N62661.AR.002639
NS NEWPORT
5090.3a

LETTER REGARDING DISCREPANCIES WITH DATA GAP FORMAT AND REGULATORY
COMMENTS ON THE DATA GAP ASSESSMENT REPORT FOR SITES 12 AND 13 NETC
NEWPORT RI
10/5/2011
RHODE ISLAND DEPARTMENT OF ENVIRONMENTAL MANAGEMENT

Re: Data Gaps Assessment (DGA) Report
Sites 12 & 13, Tank Farms 4 & 5

CERCLA Human Health Risk Assessment Process for Soil at NAVSTA Ne

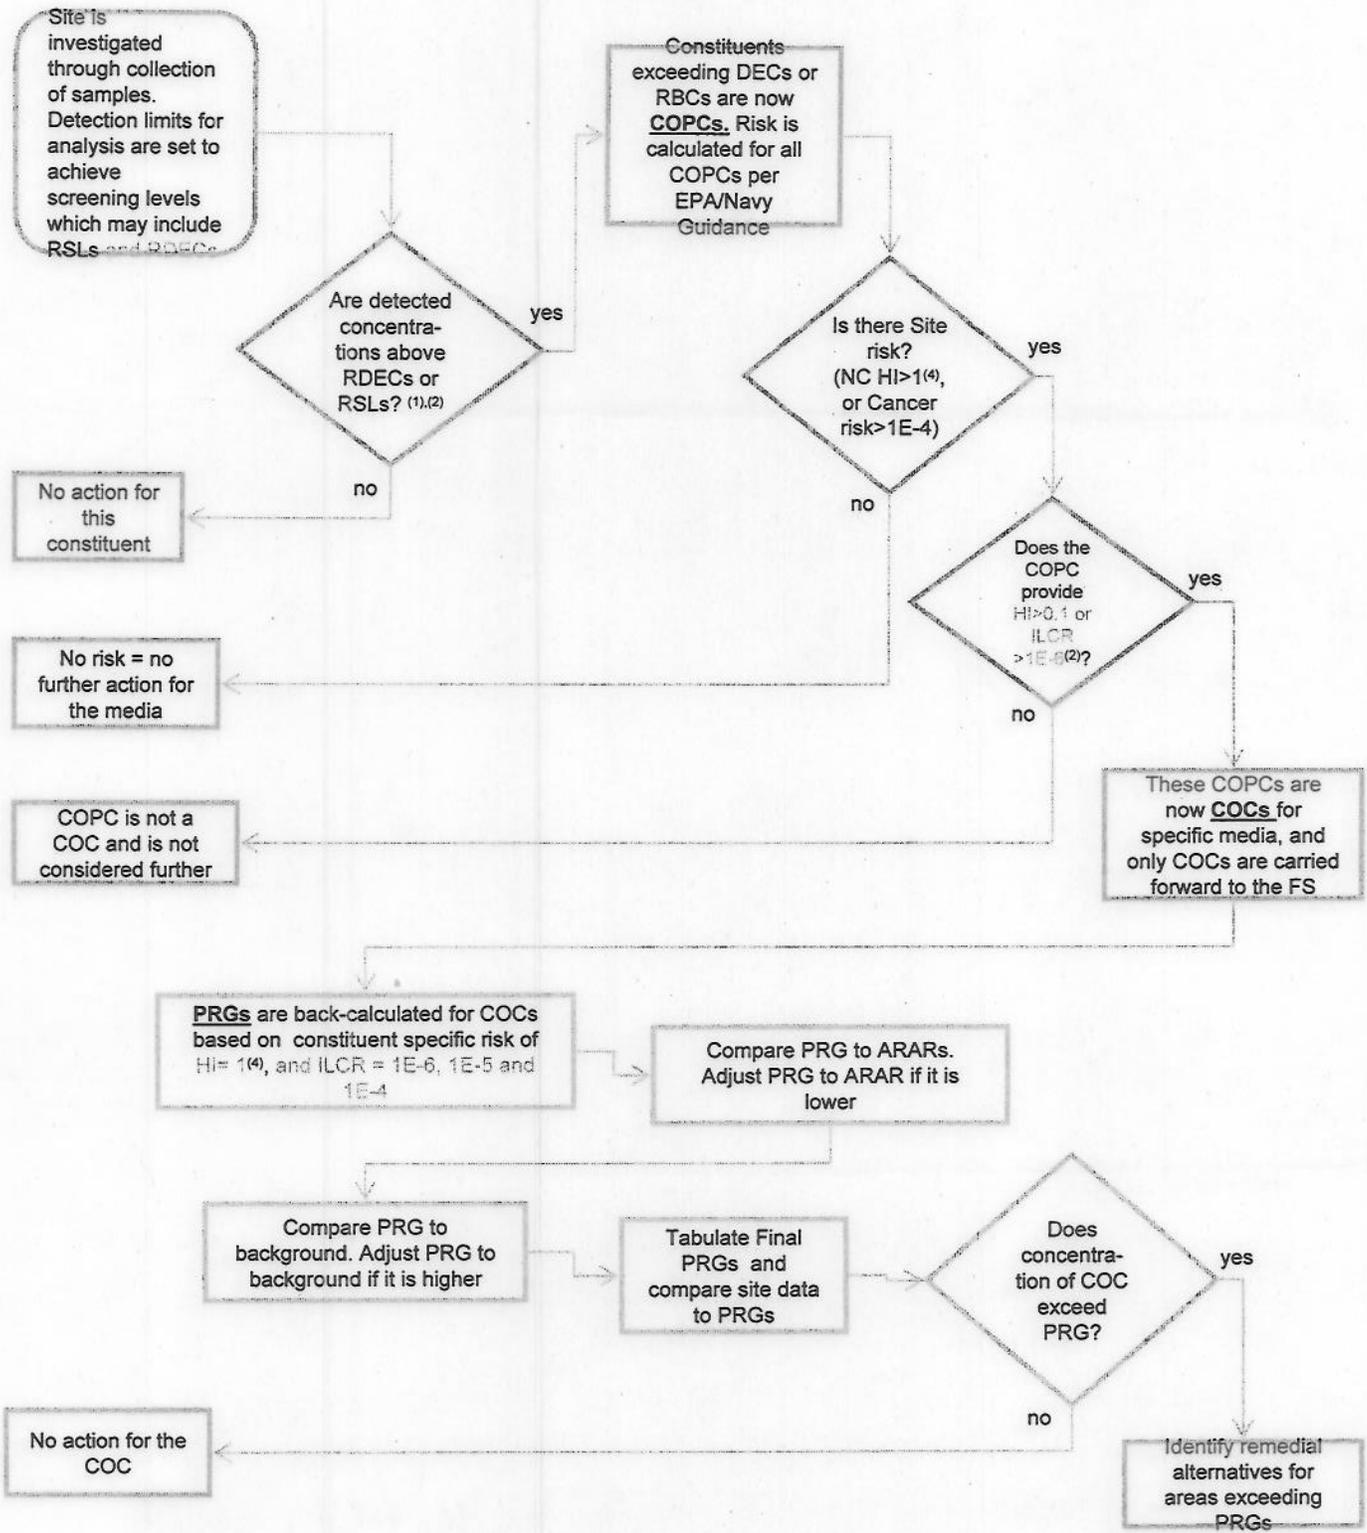
The Navy response is a direct contradiction to what was stated in the Agencies approved Sampling and Analysis Plan (SAP) (to use the lowest risk based criteria EPA RSL and RIDEM Residential Direct Exposure Criteria or RDECs) as well as the CERCLA Human Health Risk Assessment Process for Soil at NAVSTA Newport Navy Flow Chart sent to Matthew DeStefano from Timothy Reisch on 4 October 2011 (attached). In that Flow Chart, the first diamond clearly states the following: *“Are detected concentrations above RDECs or RSLs?”*
